Re: Seven Hills Townhomes Site Plan – Response to Initial Submittal Review Comments
Application No: DA-2084-01
Case Number: 2017-4017-00

OUTLOOK SEVEN HILLS TOWNHOMES
SITE PLAN
AURORA, CO

SHEET 1 OF 25

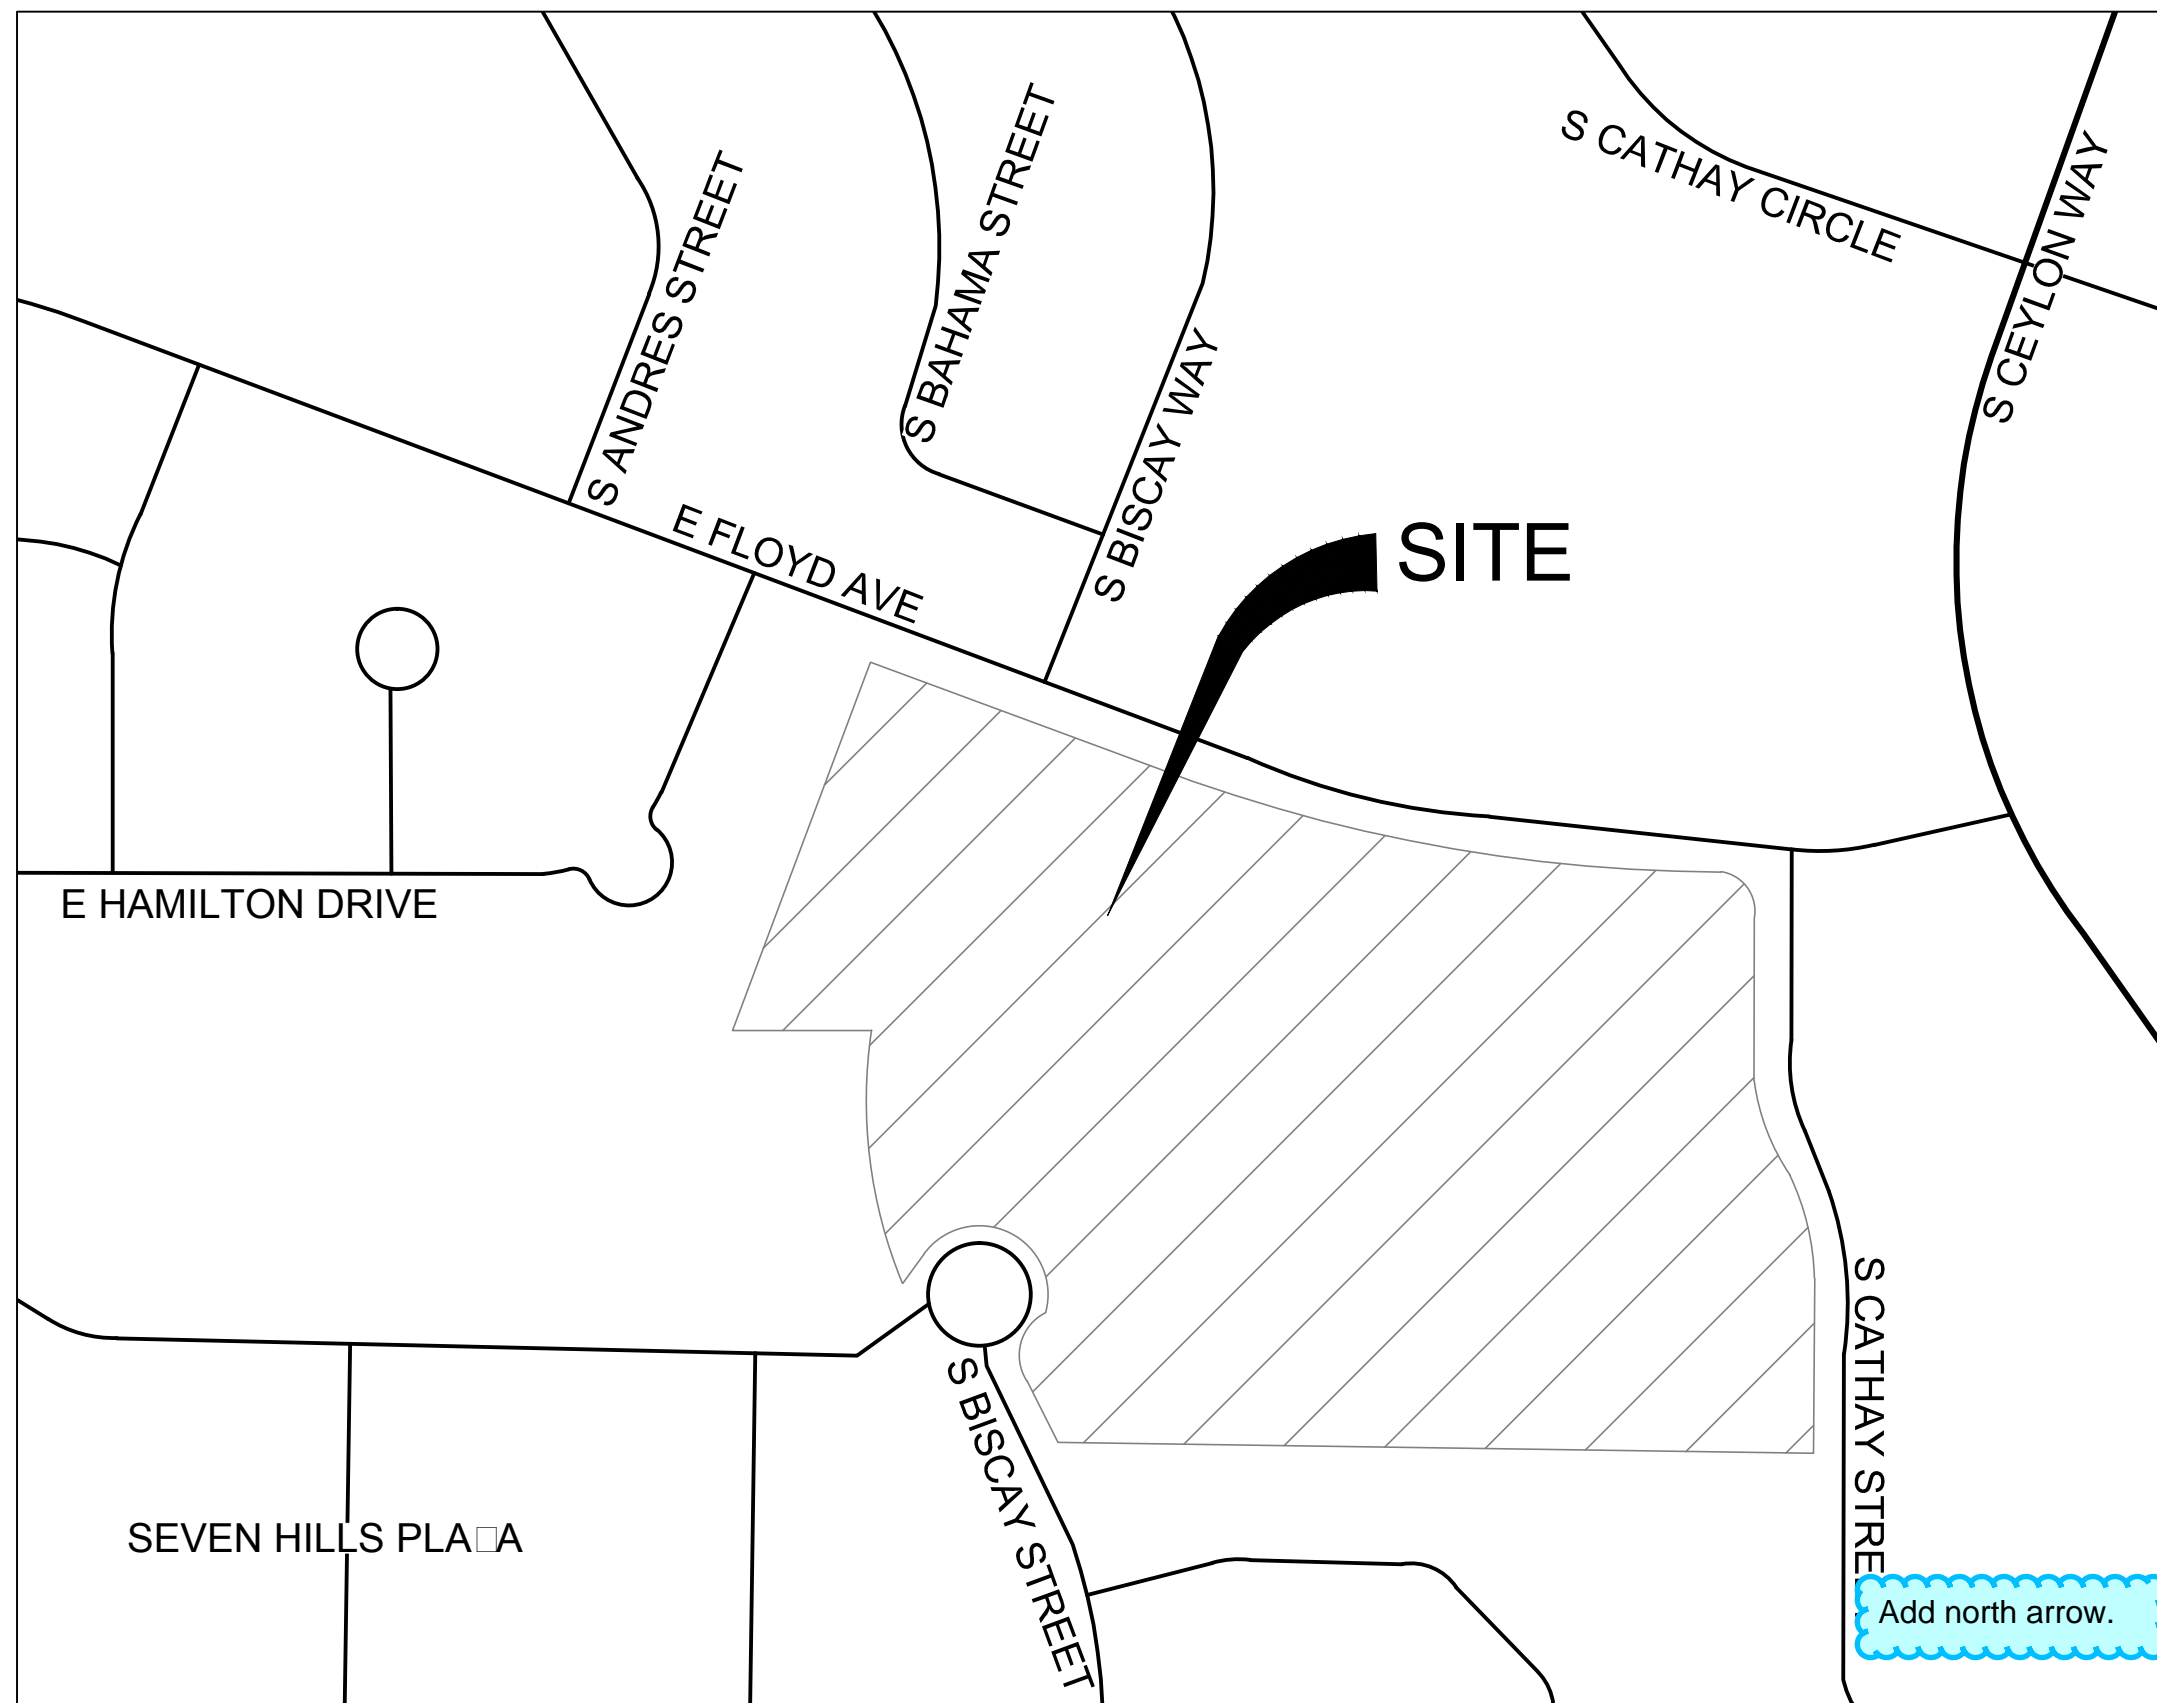
Verify correct character export with next submittal.

Export has been done correctly in order to remove characters for this submittal.

SHEET 3 OF 25

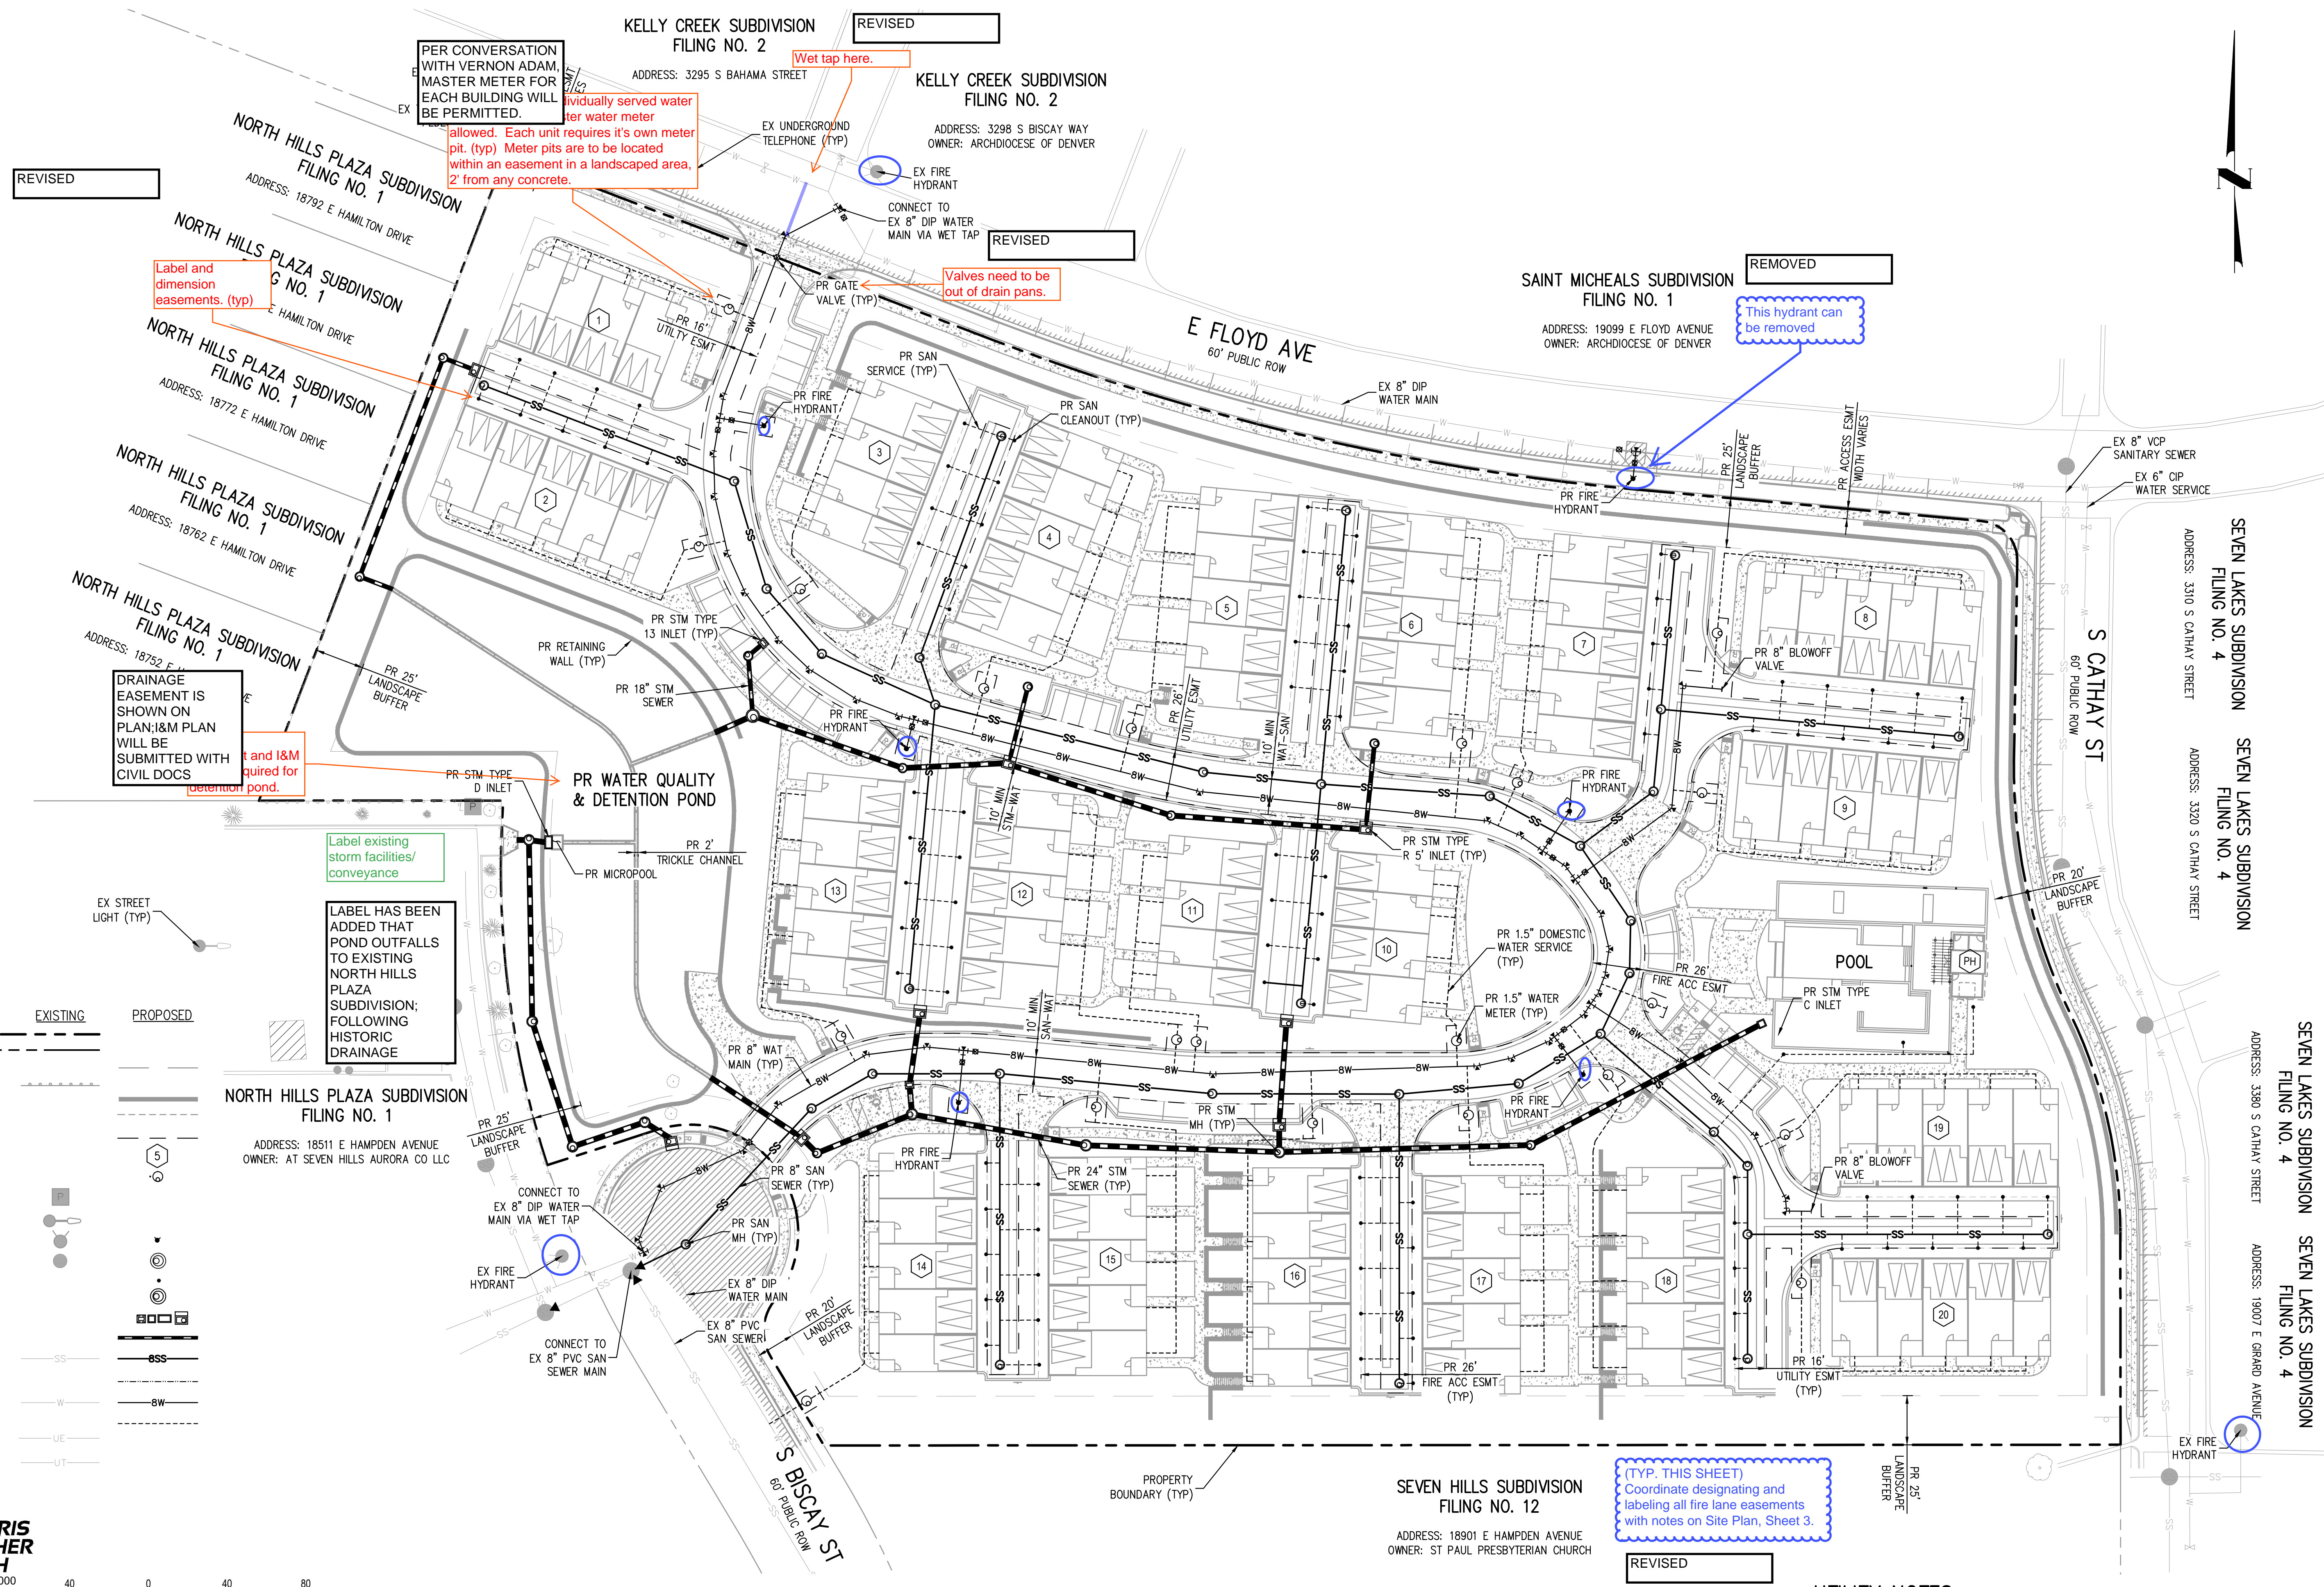
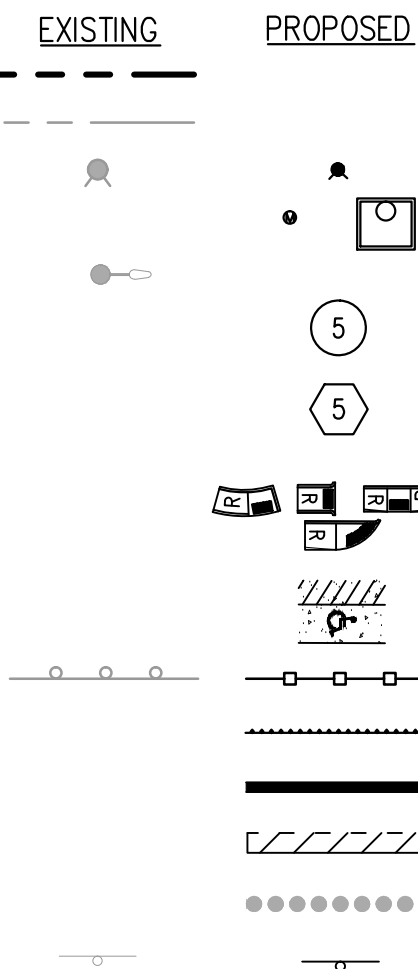
Show and note a 4' driveway gate in the area where a
fence crosses an accessible route.
- 4' MANWAY GATE WITH KNOX-APPROVED LOCKING
DEVICE
- Provide a placard on the gate reading "GATE TO
REMAIN OPEN DURING BUSINESS HOURS".
Provide note that "ANY LOCKING DEVICE SHALL BE
INSTALLED AS A KNOX-APPROVED LOCKING
DEVICE."

NOTES ADDED.

1 FRONT ELEVATION - 5-PLEX
1/8" = 1'-0"

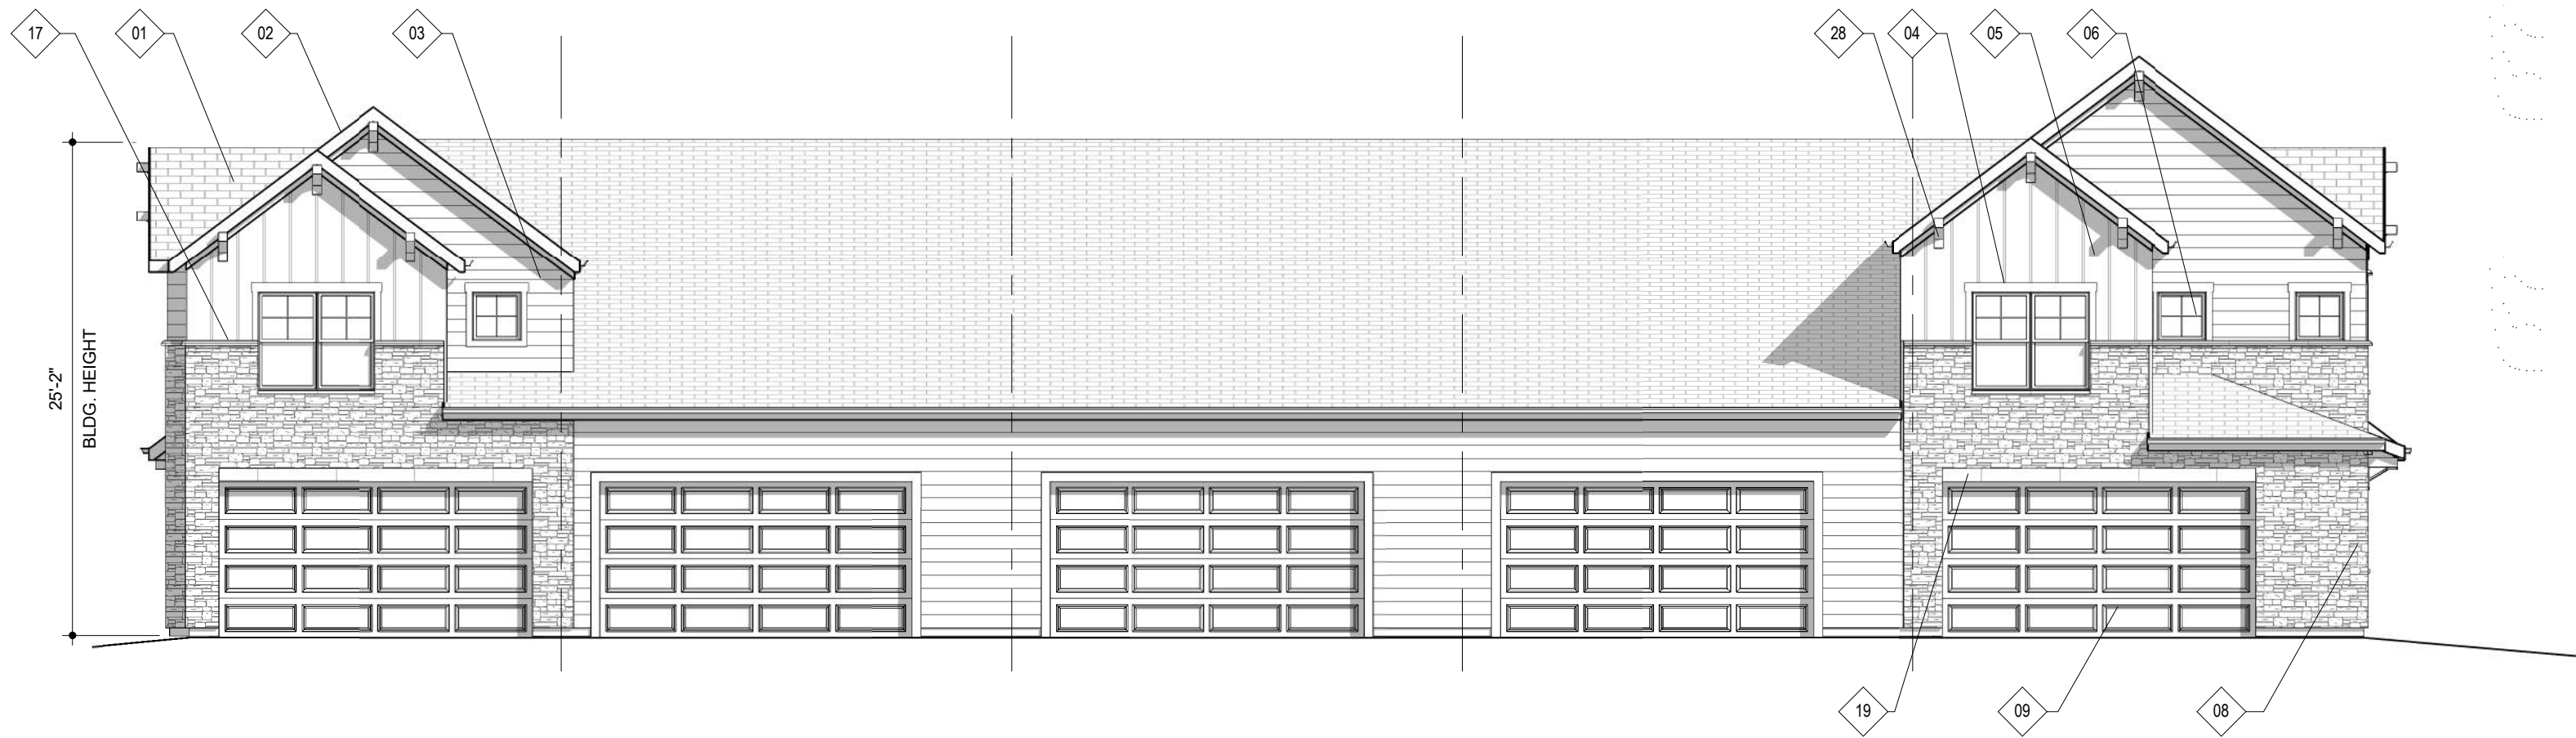
(TYP. SHEETS 7 AND 8) Add Note:
NEW RESIDENTIAL BUILDINGS SHALL BE PROVIDED WITH
APPROVED ADDRESS IDENTIFICATION THAT IS LEGIBLE AND
PLACED IN A POSITION THAT IS VISIBLE FROM THE GARAGE SIDES
AND THE FRONT ENTRANCE SIDES FRONTING ONTO GREENBELTS.
NUMBERS SHALL BE NOT LESS THAN 4" HIGH WITH A MINIMUM
STROKE WIDTH OF 1/2 INCH. (2015 IFC, 505.1)

RESPONSE: Note added to
sheets 7 and 8.

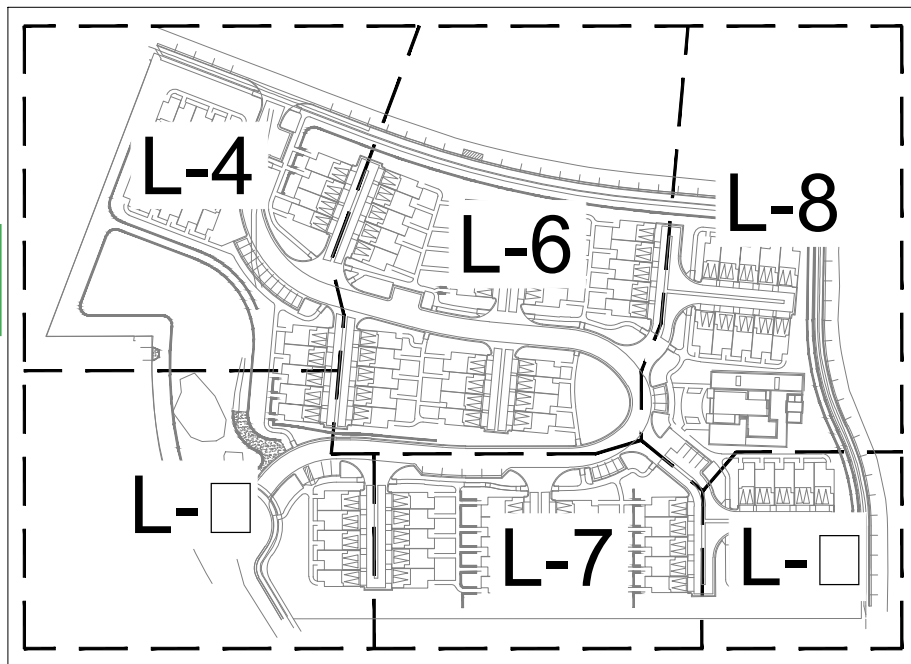
Remove if not used.

This has been corrected.
